ASCE 41-17 Tier 1 and Tier 2 Seismic Evaluation Report Rossmoor Buildings:

600 Terra California Drive, Walnut Creek, CA

December 12, 2022

IDA Job No. 22054

DEFICIENCIES AND MITIGATIONS

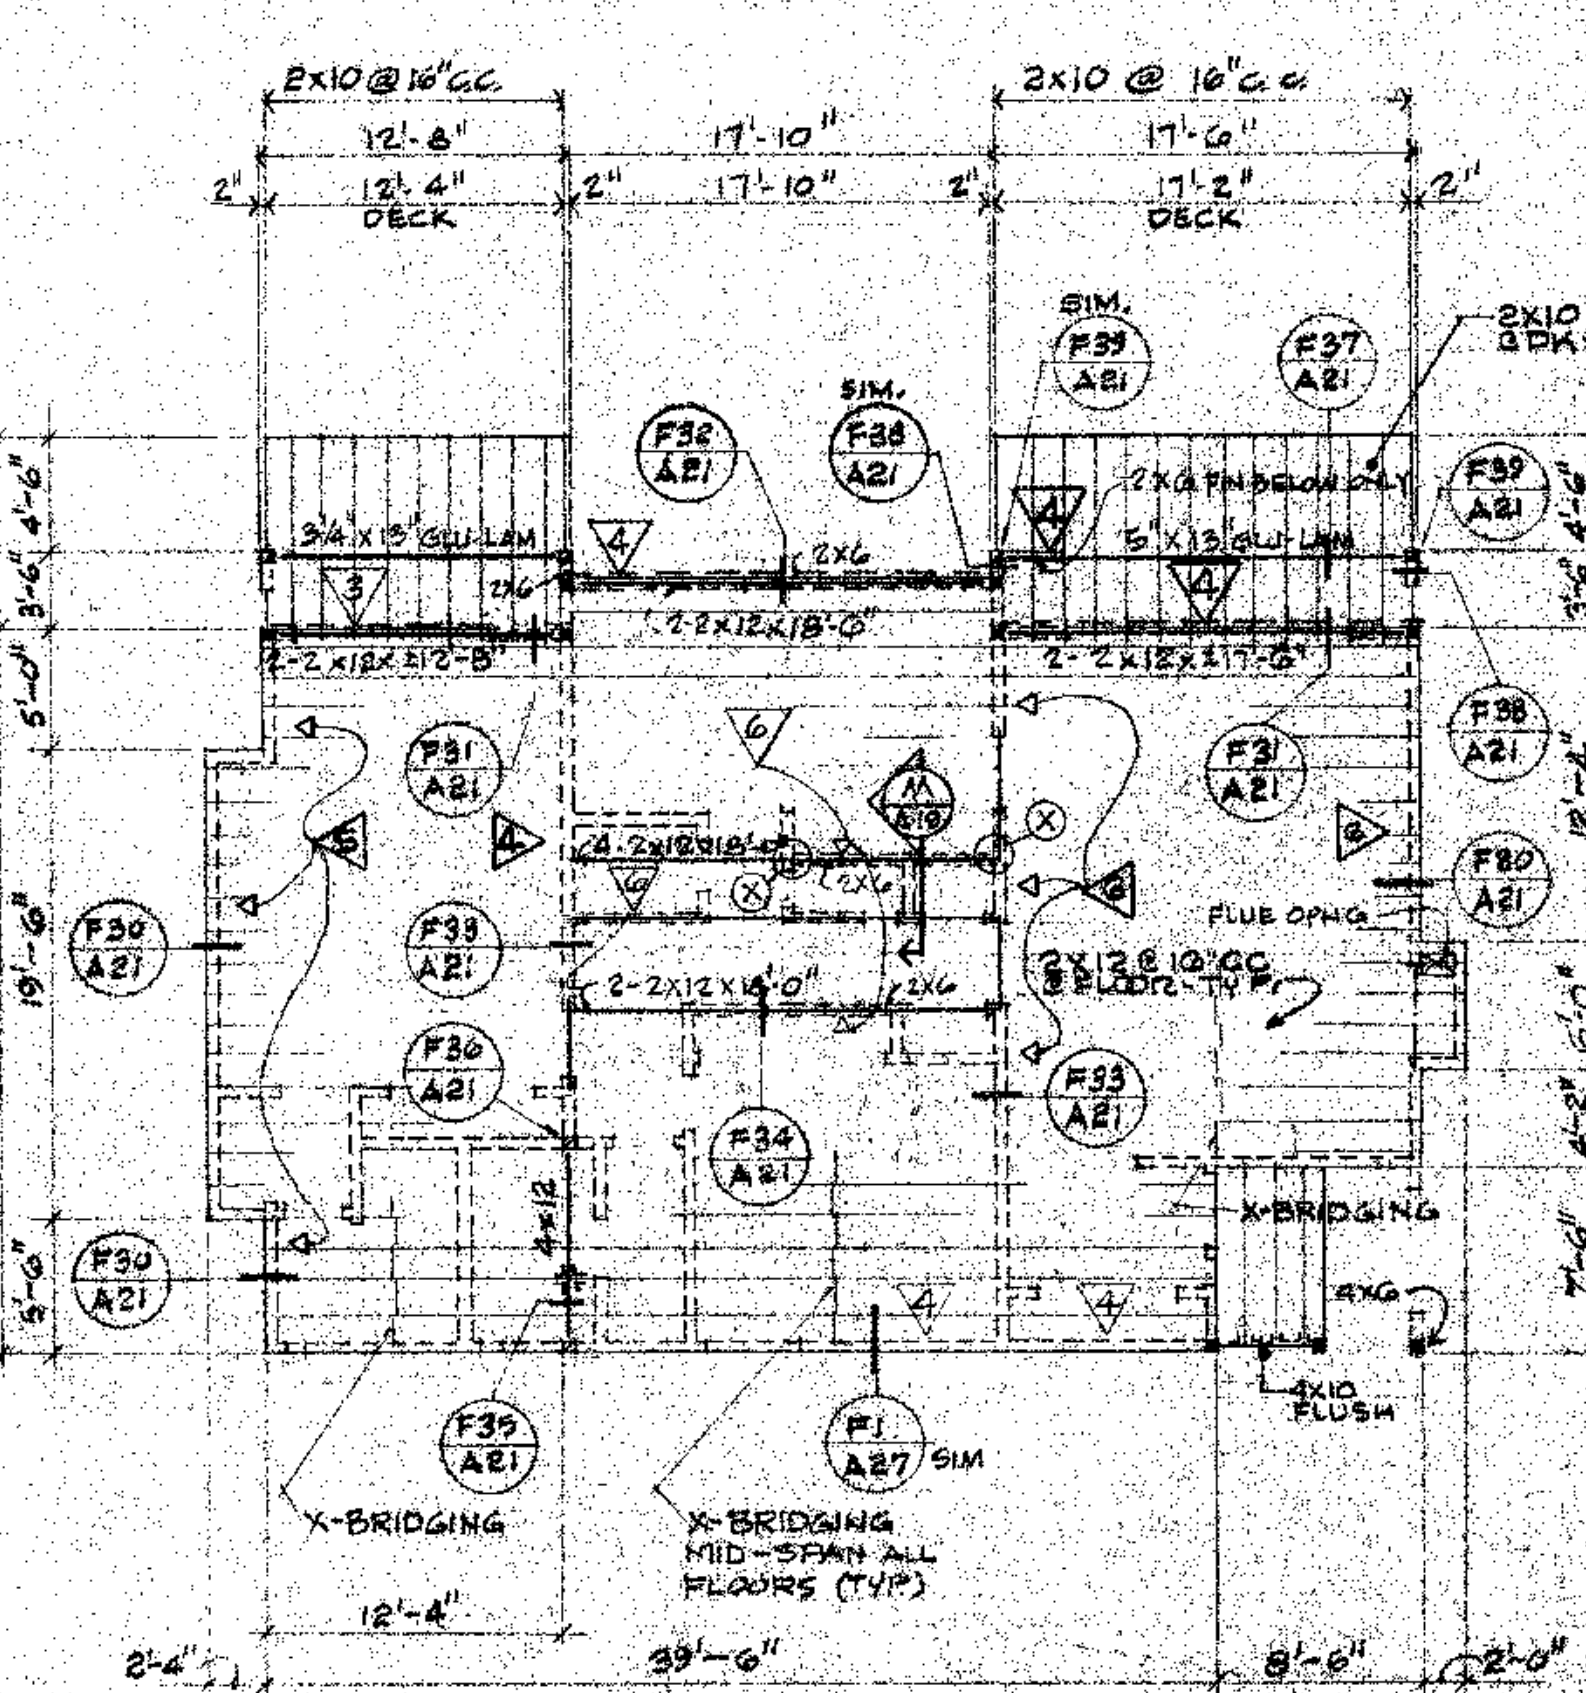
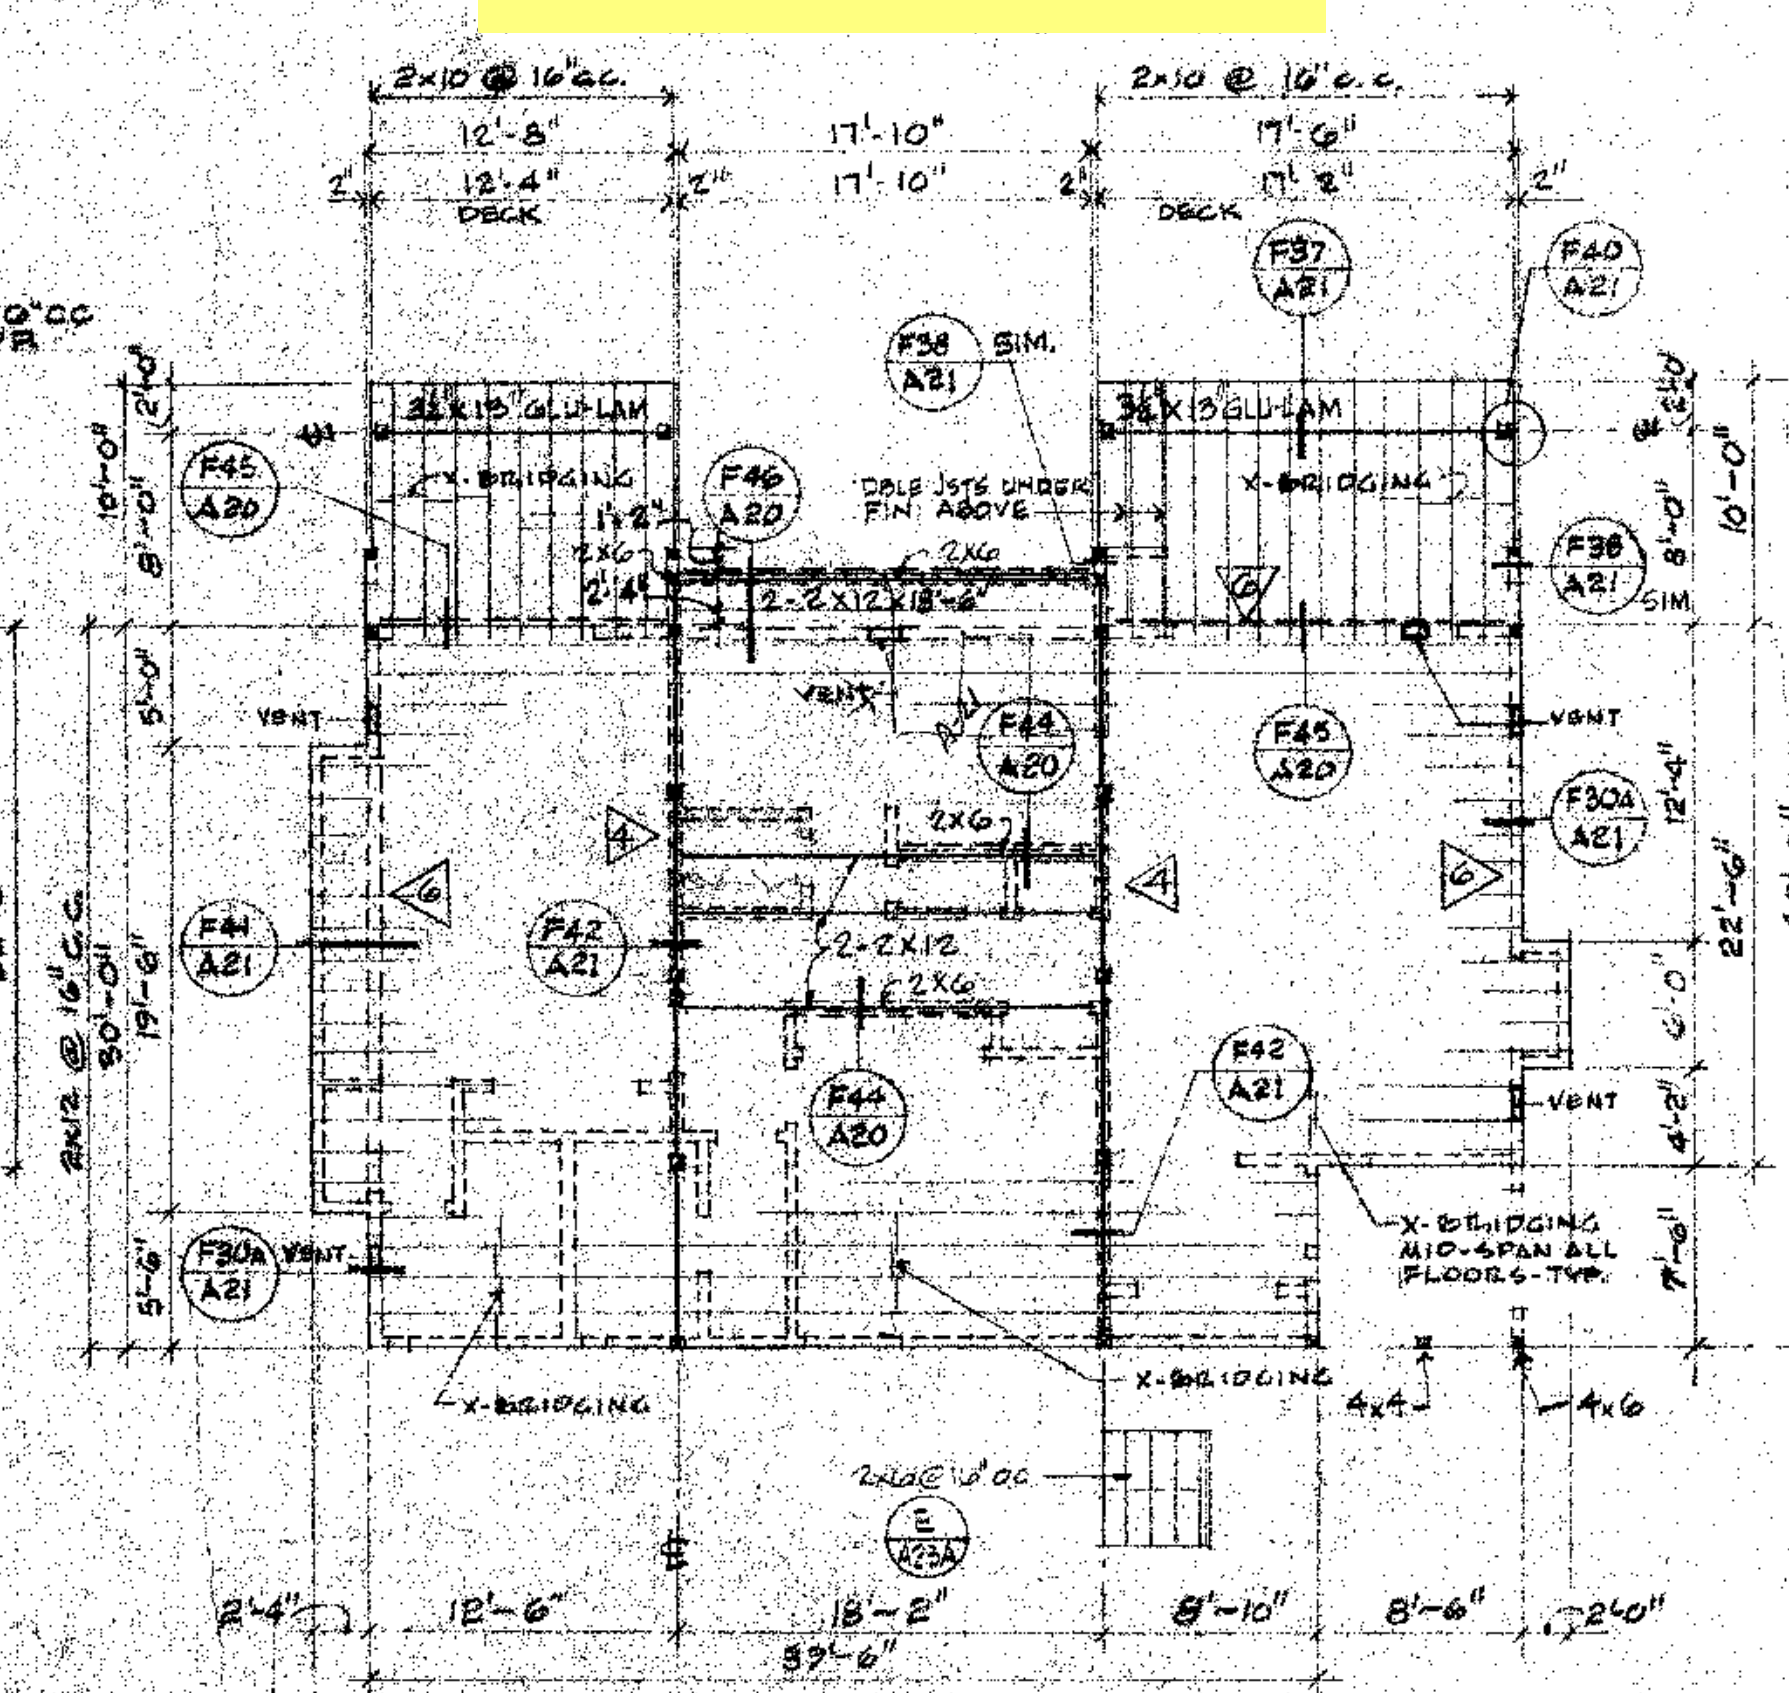
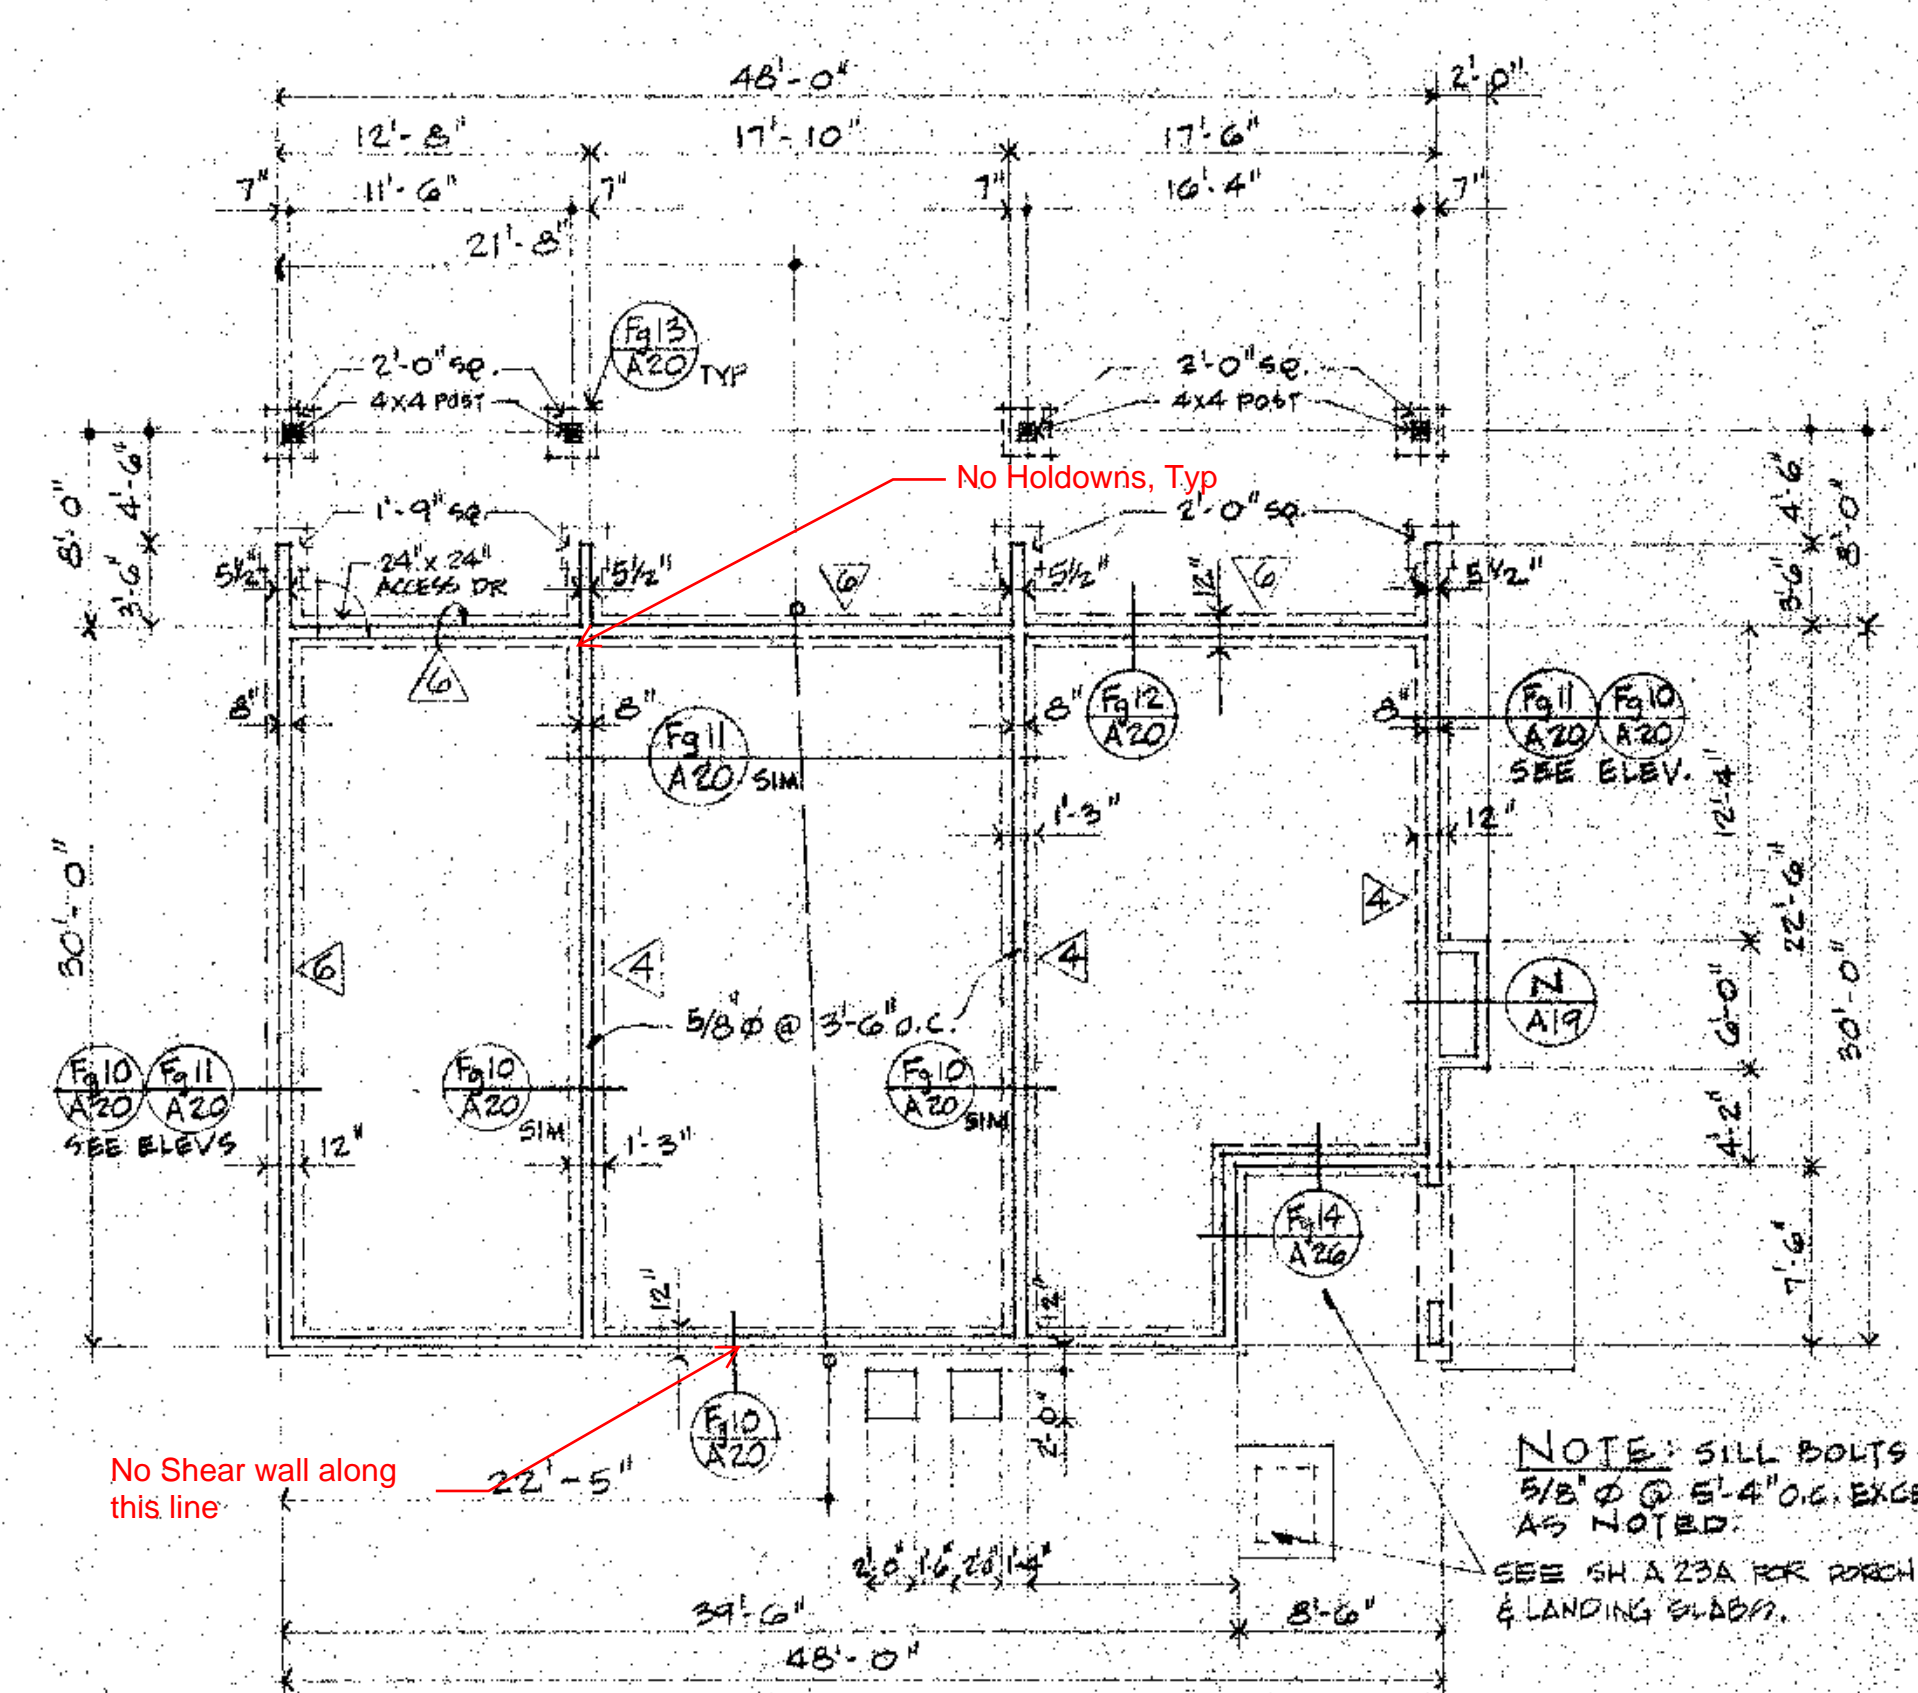
This building has a redundancy of lateral force resisting system in both the unit plans. Tier 2 evaluation of the shear walls finds that the shear stress checks are not compliant. The shear stresses in some walls exceed the assumed capacity of the walls. The wall lines which require strengthening are identified in the mitigation plan.

No Holdowns on this floor

The most prudent retrofit strategy for a building without redundancy is to add new seismic force resisting elements. New shear walls may be added. Other mitigations include adding sheathing to interior and exterior walls and adding or prefabricated shear resisting elements.

At existing plywood shear walls, new plywood sheathing should be added to the opposite side of the walls (creating double sided plywood shear walls) so that shear capacity is significantly increased.
